AS104 NOTES:
CEILING & BAL BEAMS REVISIONS NOT CLOUED

SQ ALEXANDRA PARK - BLOCK 11
38 CAMERON ST., TORONTO, ONTARIO M5T 2H2

Teepie Architects
LEVEL 14 PLAN

1 LEVEL 14 PLAN
A225 1:50

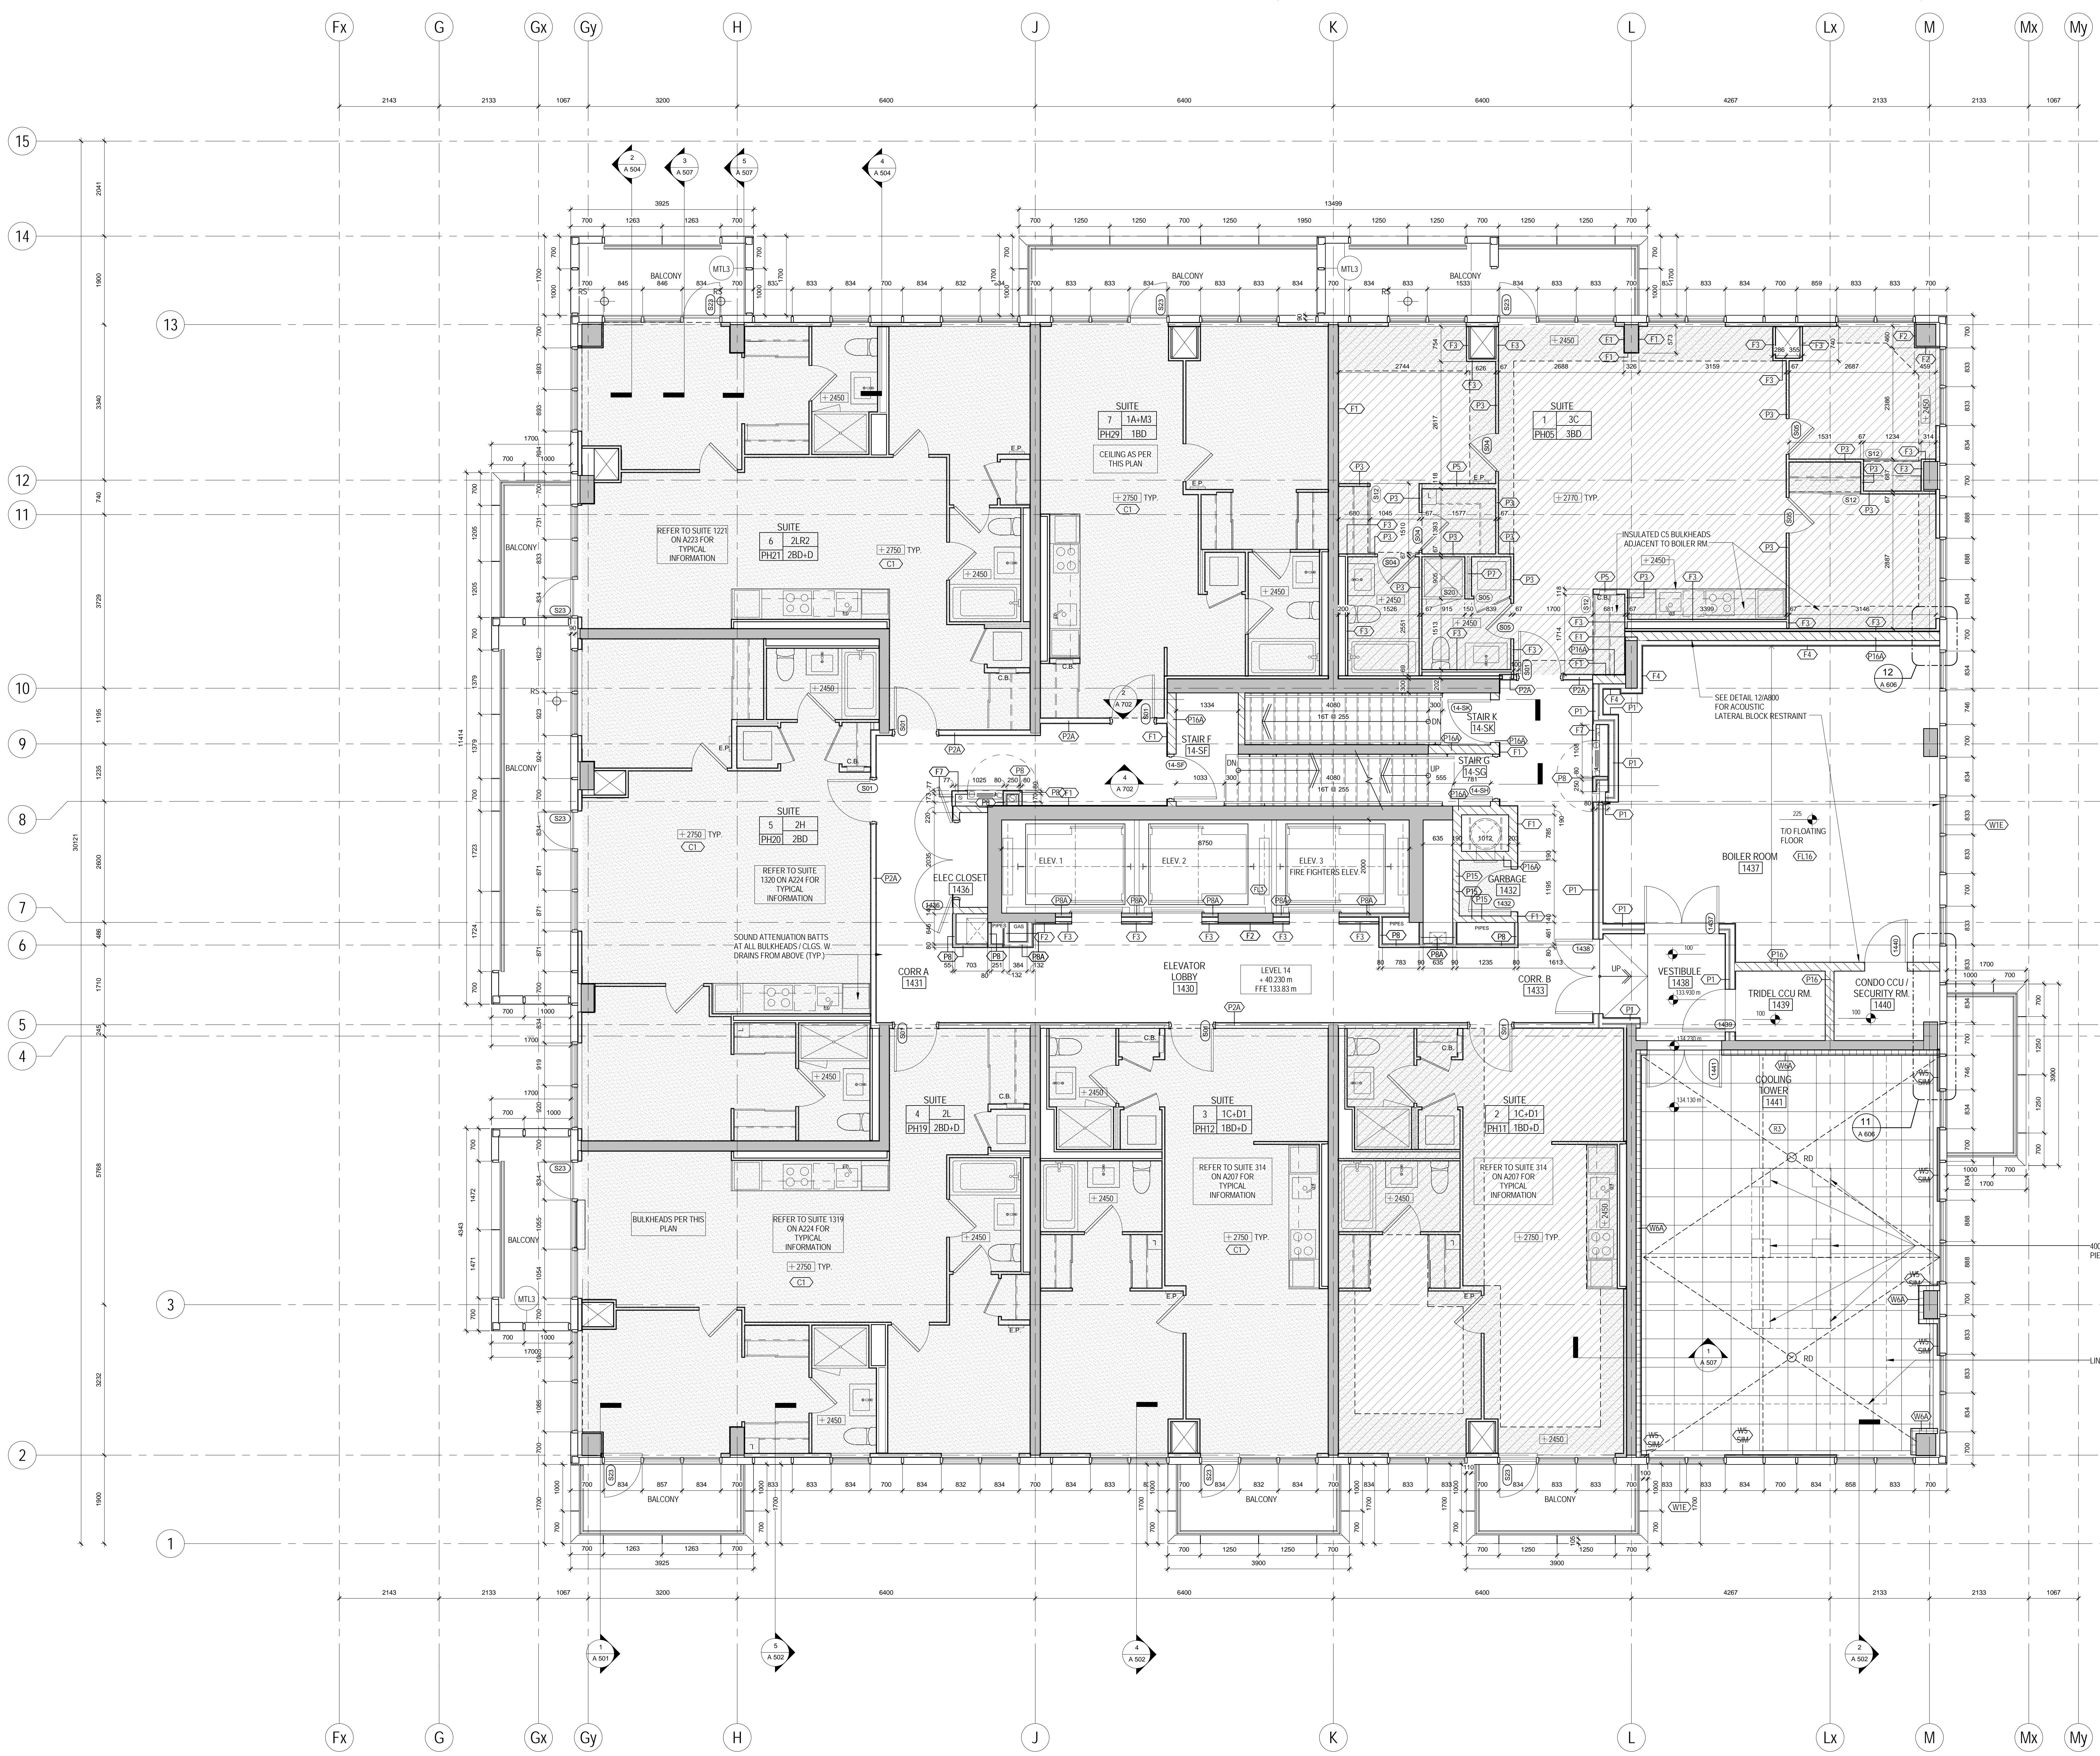
SUITES PH05 AND PH11:
ACOUSTIC CEILING C3 AT +2750 THROUGHOUT SUITE. ROUTE RWL AND/OR CEILING DUCTS AND SPRINKLERS IN TYP. BULKHEADS AT +2450 BELOW ACOUSTIC CEILING.

ALL OTHER PH SUITES:
INSULATED CEILING C1 AT +2750 THROUGHOUT SUITE. ROUTE SPRINKLERS AND DUCTS IN TYP. BULKHEADS AT +2450. INSULATE BULKHEADS - DO NOT EXTEND C1 CEILING ABOVE BULKHEADS.
